45CLFW 8100: Cooling System Updates (4B)

Property name and top bus number: NABI 45CLFW 8100 series buses

Issue: Air in the cooling system.

Reason/ cause: Cooling system was updated to enhance de-aeration.

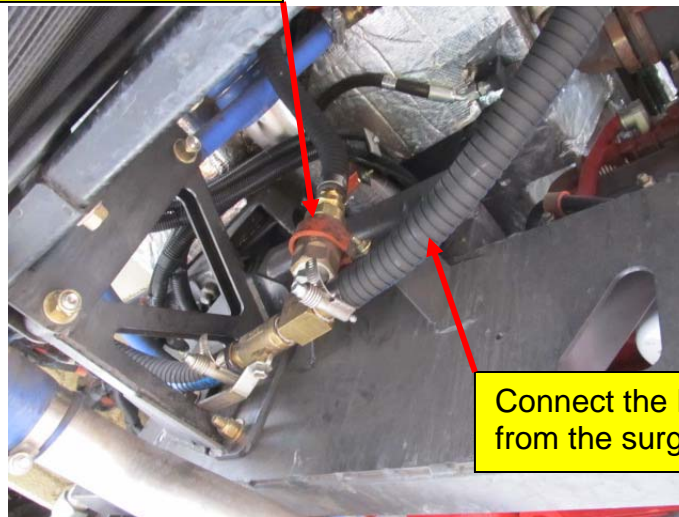
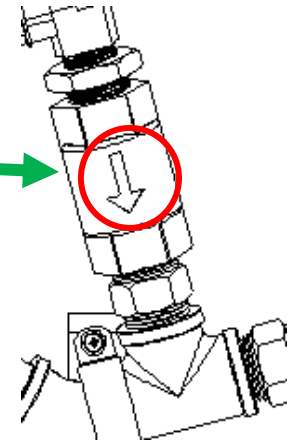
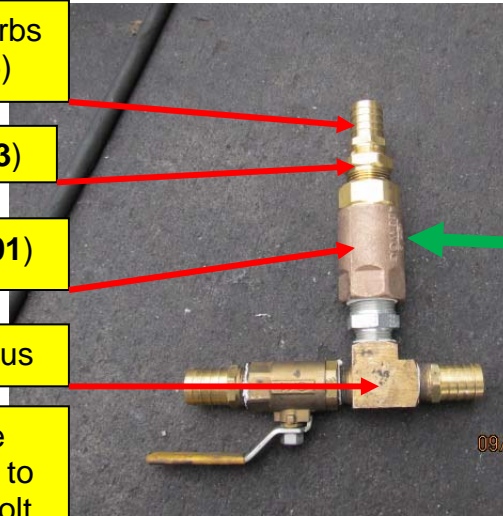
- Remove heater return hose in between ¼ turn valve at heater return tube and ¼-turn valve at lower radiator tube.
- At the lower radiator tube, remove ¼ turn shut off valve and install plug in port.
- Install check valve with fittings as pictures show below.

16MP-16HO hose barbs
(PN 436.00.1355.905)

Nipple (PN 5030503)

Check valve (PN 5000001)

Use existing Tee and ¼-turn valve on bus

Install check valve / Tee / 1/4-turn valve assembly here. Secure valve assembly to the bracket with P-clamp and ¼-20x1 bolt.

Connect the EZ-form hose coming from the surge tank to the here.
